DISAPPROVED
 Plan Review

EPC Planning & Community
 Development Department

RESIDENTIAL ADDITION for GUY & SUZANNAH MARTIN
 10275 EAGLENEST DRIVE, COLORADO SPRINGS, CO. 80930

SITE PLAN 1" = 120'

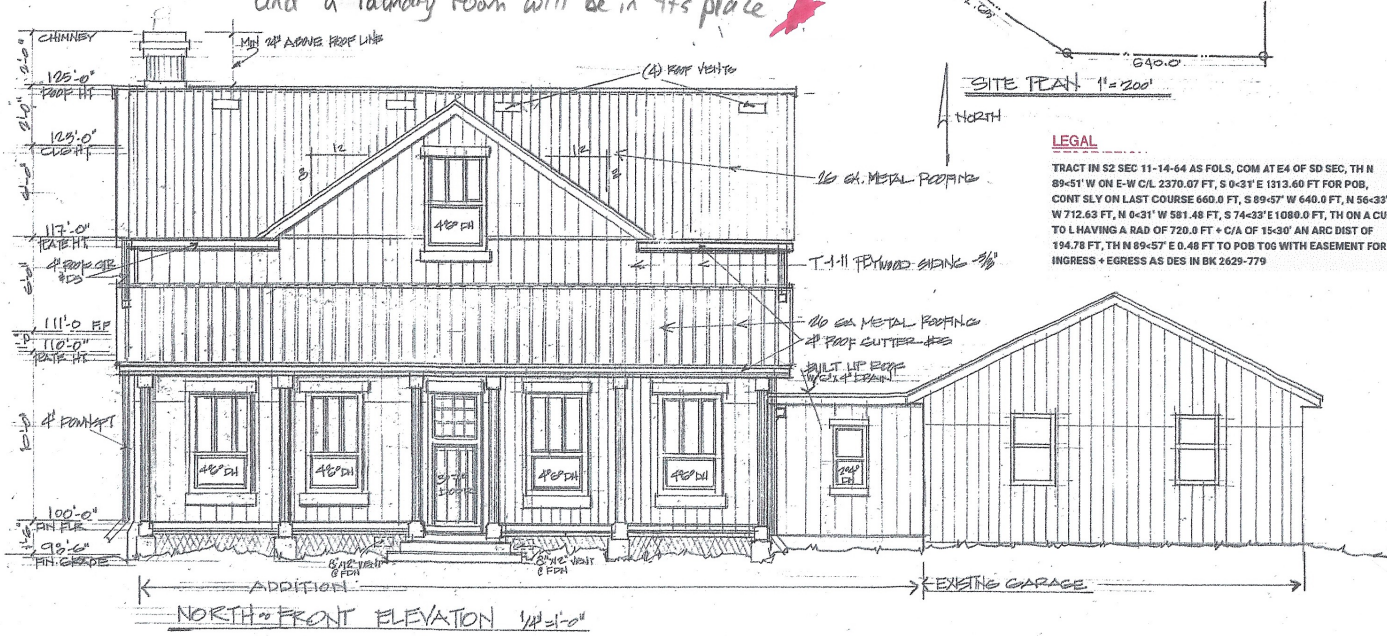
- 1) ADDRESS RBD CONSTRUCTION COMMENTS.
- 2) IF EXISTING KITCHEN IS NOT BEING REMOVED, ALL MEMBERS ON TITLE FOR PROPERTY MUST COMPLETE A SECOND KITCHEN COMPLIANCE AFFIDAVIT (A COPY OF WHICH HAS BEEN UPLOADED INTO PLAN SET), HAVE THEIR SIGNATURES NOTARIZED AND RECORD THE ORIGINAL SIGNED, NOTARIZED AFFIDAVIT WITH EL PASO COUNTY CLERK AND RECORDERS OFFICE.

Only one kitchen. old kitchen will be removed
 and a laundry room will be in its place

A-2
1/30/2020

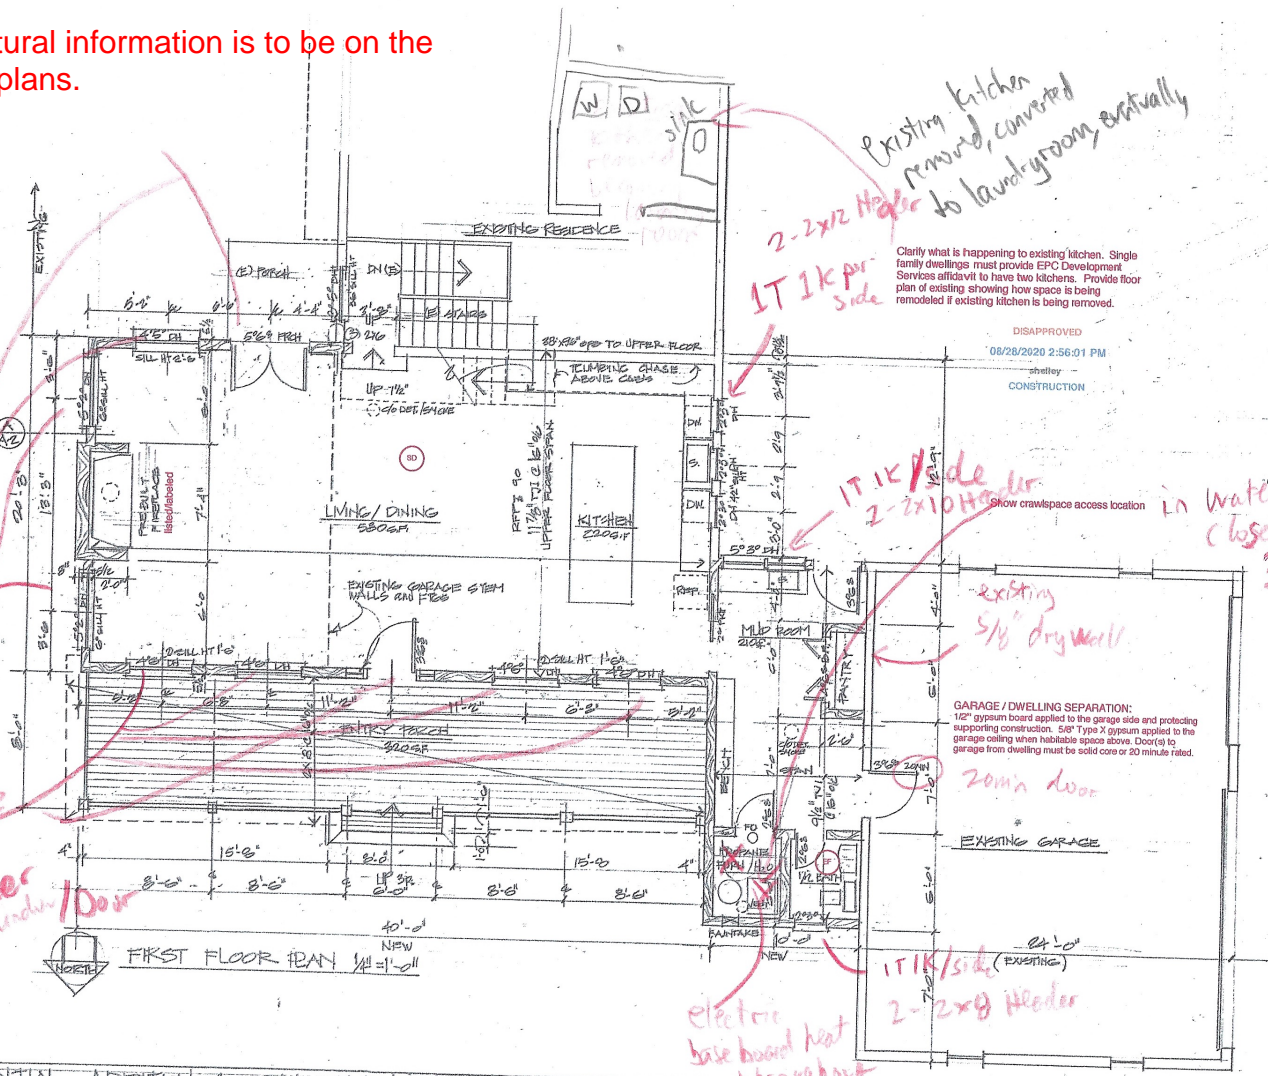
All structural information is to be on the framing plans.

1T 1K/side for 2-2x12 Header
show crawlspace access location

Garage / Dwelling Separation:
1/2" gypsum board applied to the garage side and protecting supporting construction. 5/8" Type X gypsum applied to the garage ceiling when habitable space above. Door(s) to garage from dwelling must be solid core or 20 minute rated.

Existing Kitchen removed, converted to laundry room, eventually
2-2x12 Header
1T 1K per side

DOOR/WINDOW HEADER DETAILS

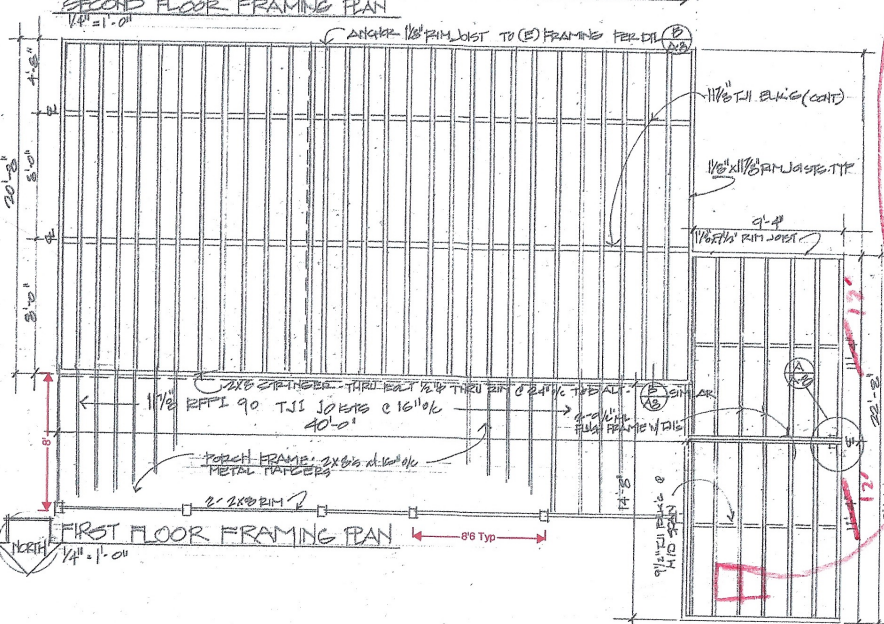
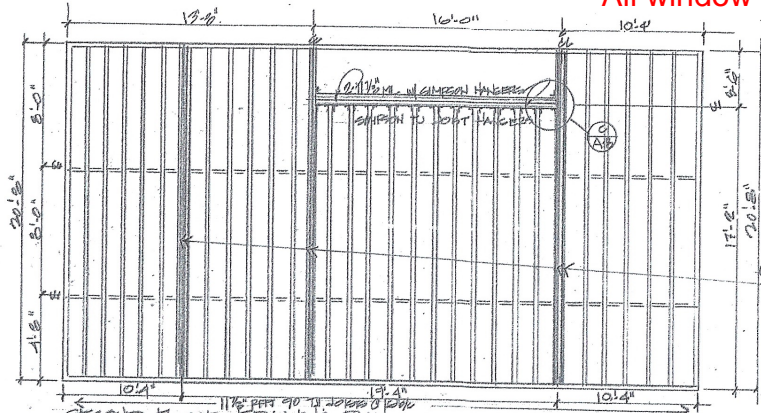
All window locations need to be shown on framing plans

A/B 1/30/2019

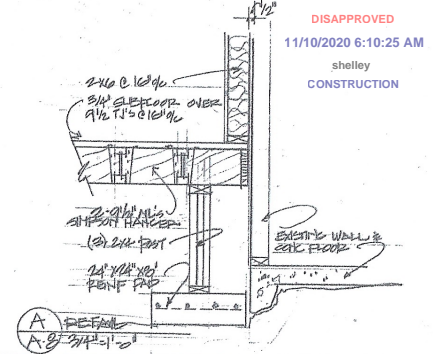
Show crawspace access framing
Show and specify all headers, kings, and trimmers
LIMITED STRUCTURAL REVIEW
